I have a couple of questions regarding the interpretation of front setbacks, lot line and street line for 63 Old Hill Road when you have time. Attached please find the record map 9295 and the most recent Site Plan dated 3-22-24 from Land Tech and the prior issued Site Plan dated 10-19-23. The 3-22-24 Site Plan measures the setback from the edge of the pavement of Side Hill Road and the 10-19-23 Site Plan measures the front setback from the lot line.

> Re: 63 Old Hill Road, Westport, CT Denial of Issuance of Zoning Permit for Pickleball Court

63 OLD HILL ROAD WESTPORT, CT

SITE IMPROVEMENTS FOR A PROPOSED PADDLE TENNIS COURT

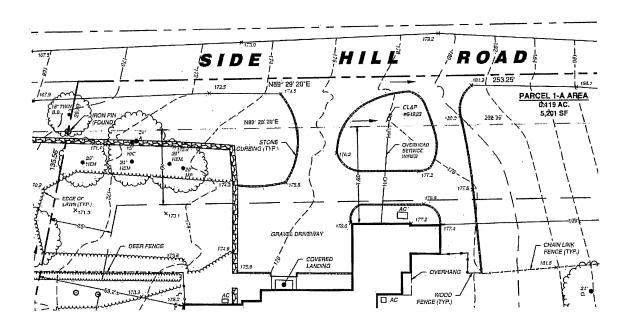
This letter is in response to your request for a zoning permit for the construction of a pickleball court at 63 Old Hill Road. As the pickleball court is proposed to be located in the front setbacks, the zoning permit as presented will not be issued. The front setback along Side Hill Road is measured from the edge of the Right of Way of Side Hill Road, per sec. 5 of the Westport Zoning Regulations as follows:

This is consistent with prior practice of the Westport Planning and Zoning Department. Per the Westport Zoning regulations, the area of Side Hill Road that is **on** 63 Old Hill Road, is removed from the lot area. As such, P&Z has decided it is consistent to measure the setbacks from the edge of the Right of Way, as this area has been removed from the lot area.

Survey for 63 Old Hill Road by Thomas Deilus, revised

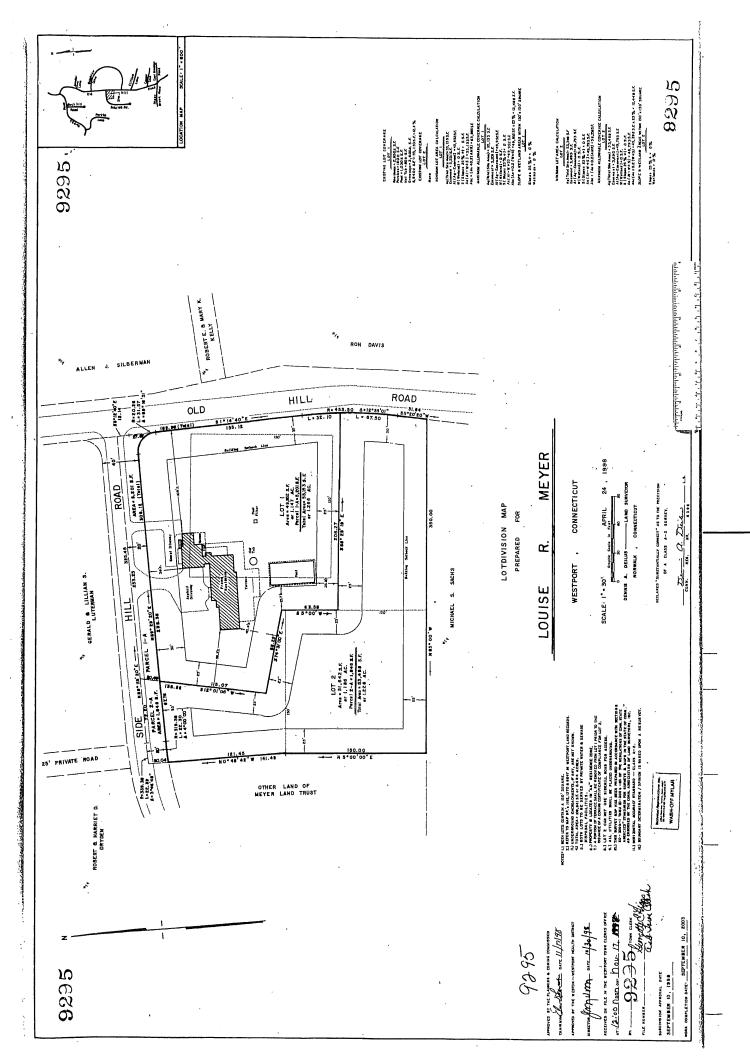
Below please find a portion of the survey generated by LandTech, issued by Thomas Deilus, Land Surveyor, dated 1/24/23, revised on 3/6/2023, showing the Right of Way of Side Hill Road and the correct measuring of 30' front the setback. This survey was submitted to the Planning and Zoning Department on March 28, 2024. The highlighted area is the Right of Way of Side Hill Road. The 30' front setback is also highlighted.
